From: drainage <drainage@midsussex.gov.uk>
Sent: 08 July 2025 13:54:45 UTC+01:00
To: "Peter Davies" <Peter.Davies@midsussex.gov.uk>
Cc: "drainage" <drainage@midsussex.gov.uk>
Subject: 2025.07.08 - DM/25/1635 - 5 Engalee East Grinstead West Sussex RH19 1FE

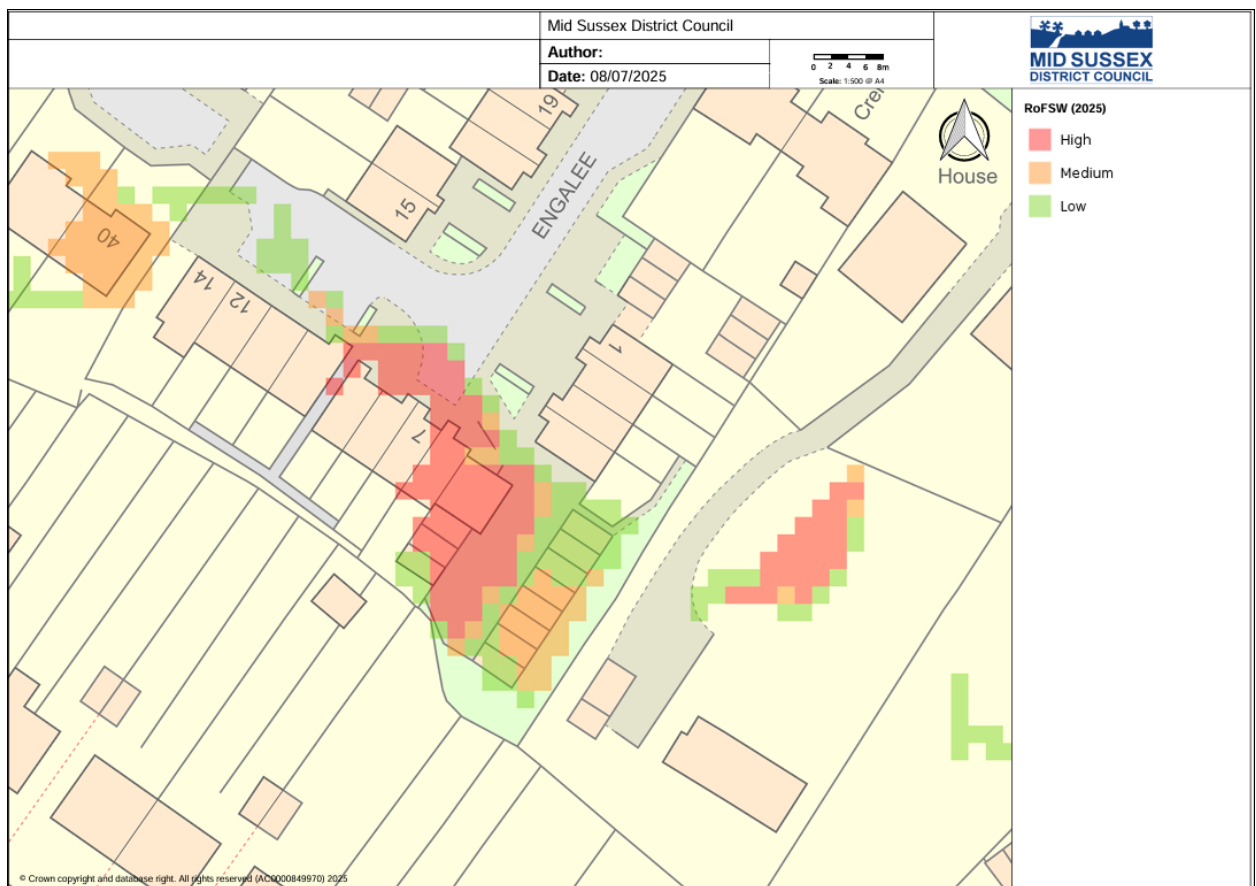
The updated Risk of Flooding from Surface Water mapping released in March 2025 shows the proposed development site is located within an area impacted by High, Medium and Low surface water flood risk.

Following the approach set out under the NPPF for assessing fluvial flood risk (flood zones) this area would be considered consistent with Flood Zone 3b, 3a and 2.

As per the Environment Agency standing advice for minor extensions, development within the 1:30 (3b) flood extent is not permissible. If the proposal is outside of this extent, then additional resistance and resilience mitigation will need to be evidenced at this location, as this development is classified as 'more vulnerable'.

In addition to a Flood Risk Assessment, we would advise that the applicant that an overlay of their proposed block plan on the above screenshot (or equivalent) of the 1:30 flood extent is required at this stage of planning for us to review any encroachment.
